SUBJECT: INCREASE IN THE SPENT FUEL POOL CAPACITY THROUGH THE USE OF HIGH DENSITY STORAGE RACKS, BRAIDWOOD STATION, UNITS 1 AND 2 (TAC NOS. 72234 AND 72235)

SAFETY EVALUATION BY THE OFFICE OF NUCLEAR REACTOR REGULATION

RELATED TO THE INCREASE IN THE SPENT FUEL POOL CAPACITY

BRAIDWOOD STATION, UNITS 1 AND 2

FIGURE 5.6-1

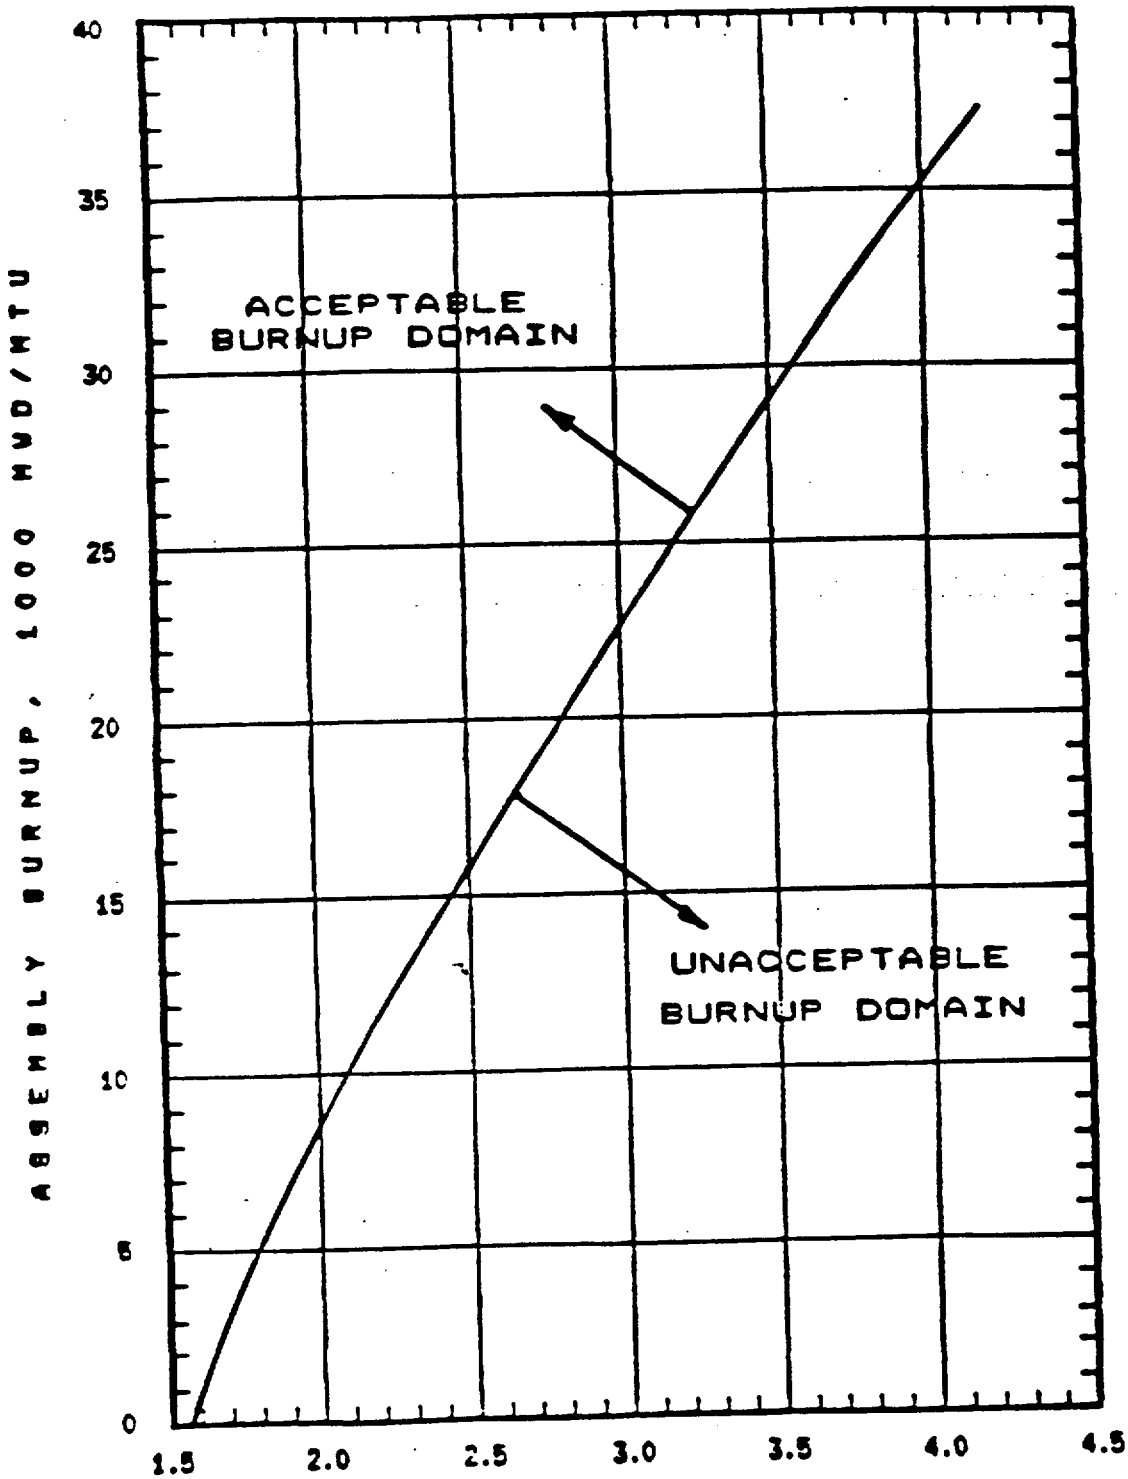
with the methods and uncertainties of the present analyses. This is acceptable. This Specification also references Figure 5.6-1, which will be added to the Specifications, for the curve of minimum burnup as a function of initial enrichment required for storage in Region 2. This curve is consistent with the analyses and is acceptable.
